MASTER REVIEW REPORT

CASE NUMBER: C814-2012-0160.01

PROJECT NAME: 211 South Lamar Planned Unit Development

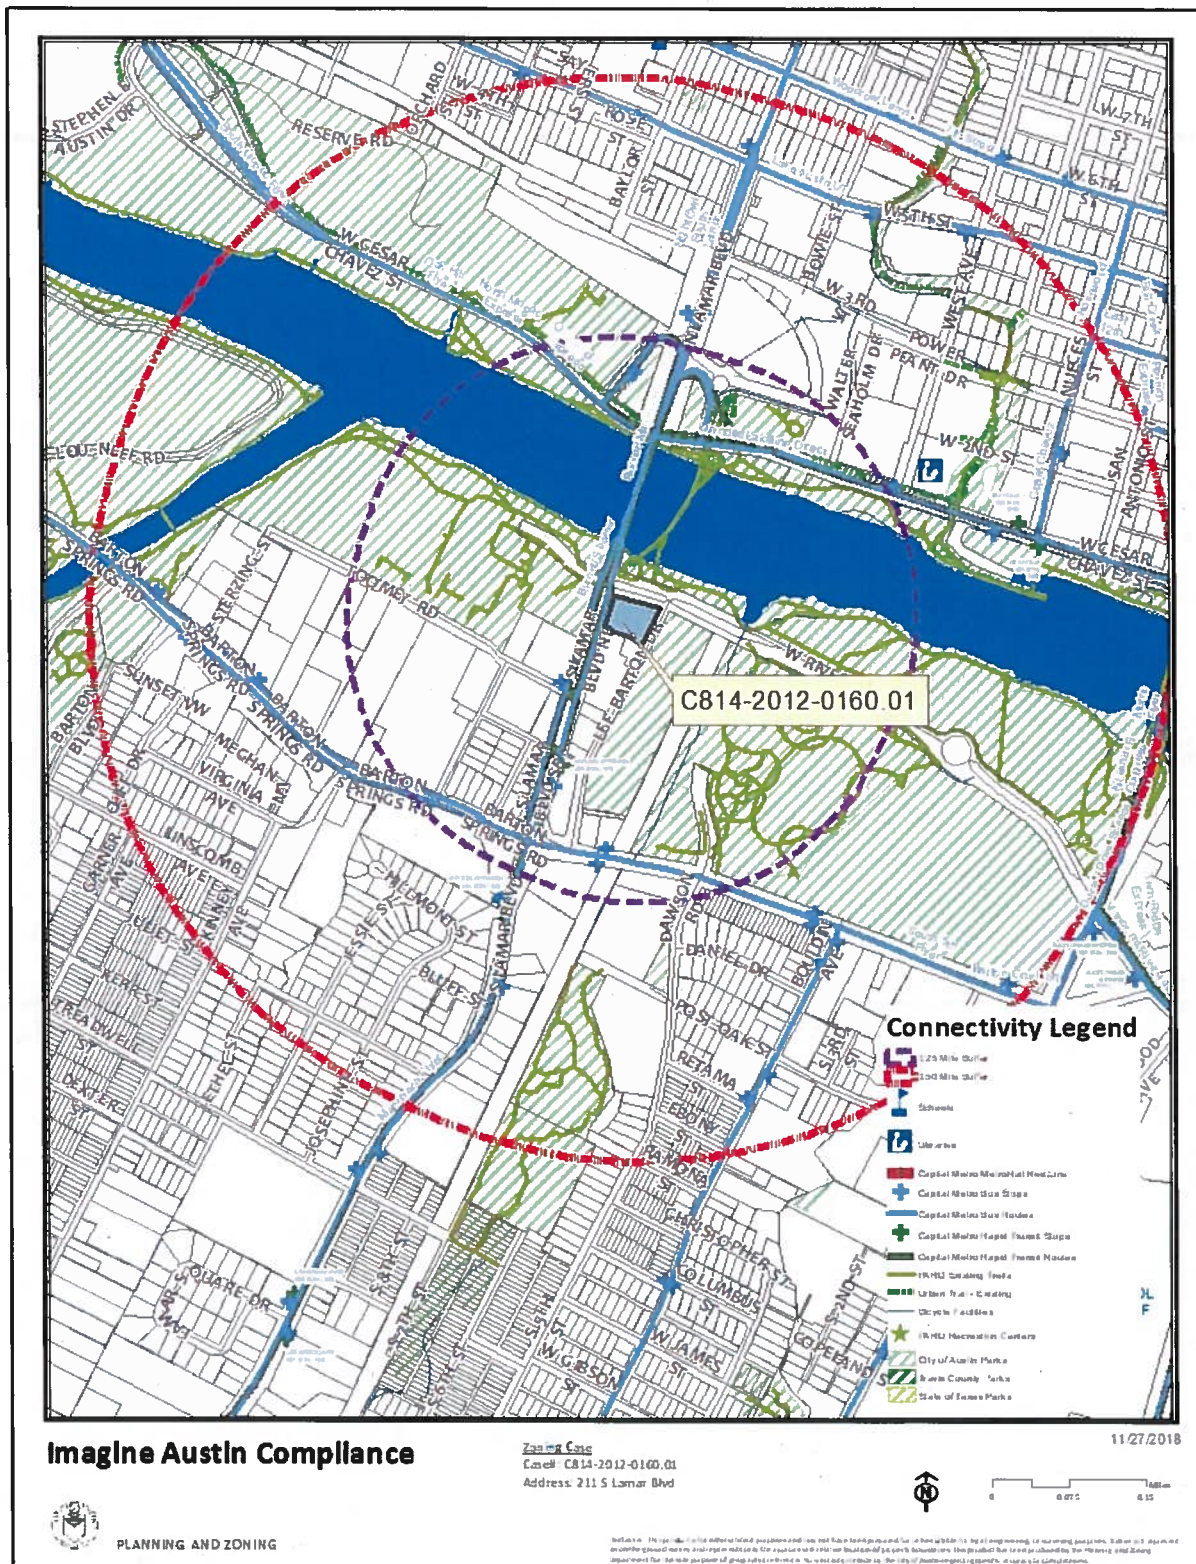
The site is located within 350 ft. to a public transit stop. Public sidewalks are located along Riverside Drive, and S. Lamar Blvd., but only partially along Lee Barton Drive. The Walkscore for this area is 86/100, **Very Walkable**, meaning most errands can be accomplished on foot. The site is within 1000 ft. of an existing urban trail. The mobility and connectivity options in this area are excellent.
